COUNCIL ASSESSMENT REPORT

Panel Reference	2017SCL036
DA Number	DA/664/2016
LGA	Randwick
Proposed Development	Demolition of the existing structures, construction of 2 x 8 storey shop top housing development within lots E1.1 and E1.2 including retail/commercial tenancies, 128 residential apartments, 2 basement levels of parking with 137 car spaces, an urban plaza, associated site, remediation and landscape works.
Street Address	164-174 Barker St, RANDWICK
Applicant/Owner	Cbus Property Sydney Residential Pty Ltd
Date of DA lodgement	20/12/2016
Number of Submissions	7
Recommendation	Approval
Regional Development Criteria (Schedule 4A of the EP&A Act)	Development that has a capital investment value of more than \$20 million.
List of all relevant s79C(1)(a) matters	<p>i.e. any:</p> <ul style="list-style-type: none"> State Environmental Planning Policy (State and Regional Development) 2011 State Environmental Planning Policy No. 55 – Remediation of Land State Environmental Planning Policy No. 65 – Design Quality of Residential Flat Development State Environmental Planning Policy (Building Sustainability Index BASIX) 2004 Randwick Local Environmental Plan 2012 Randwick Development control

Figure 1 – Approved Concept Master Plan Heights

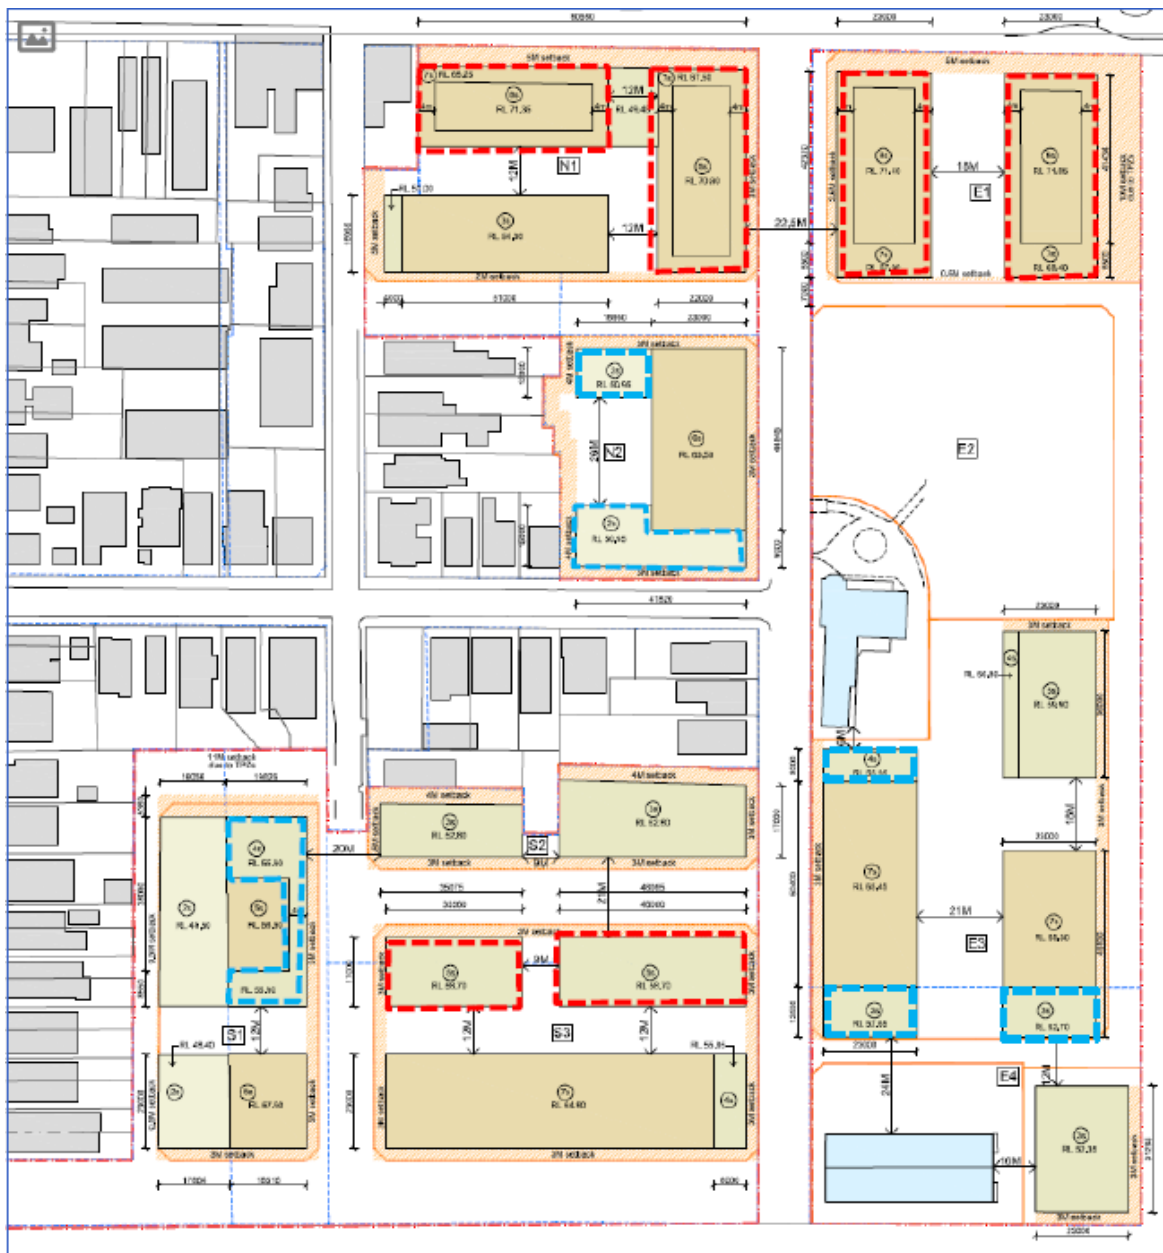
Figure 1 below identifies those buildings approved within the concept master plan which exceed the maximum height of building development standard (in red), as well as those building which provide a reduced building bulk and scale than that permitted under the Randwick LEP 2012 (in blue).

- The additional building height within Lot E1 is offset by the lower form of the buildings within Precincts S1, E3 and N2 than that envisaged through the LEP and DCP controls (refer Figure 1).

Figure 2 – Barker Street Elevation

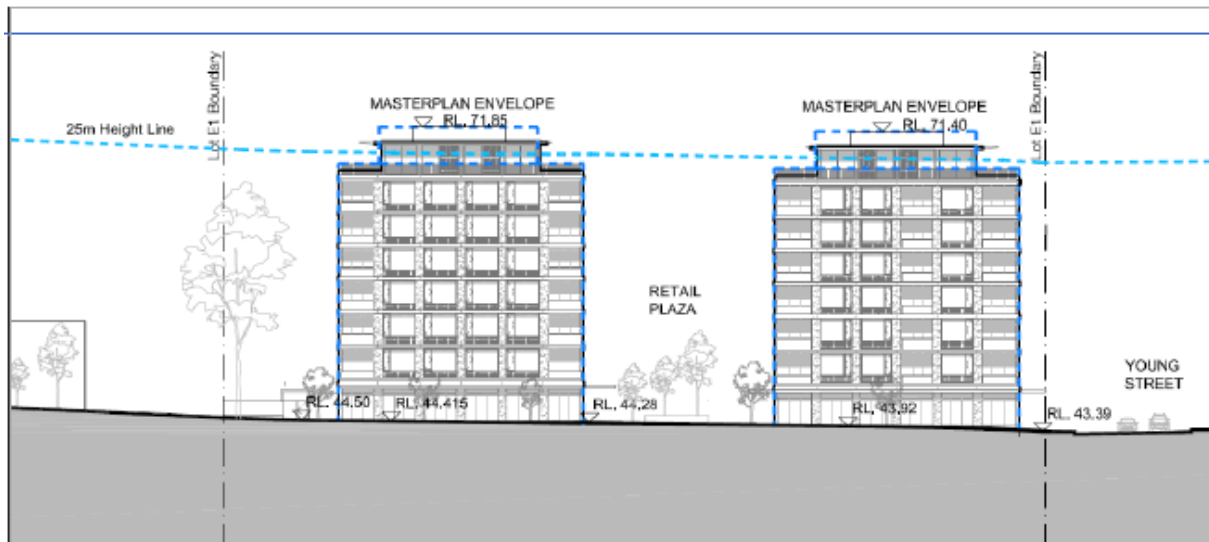
Importantly, we note that the originally submitted DA for Lot E1 proposed an 8-storey consistent built form. As part of this amended DA, the proposal involves Level 8 being setback by 4 metres to the eastern and western building edges to reduce the perceived bulk and scale of the building and reduce the associated environmental impacts.
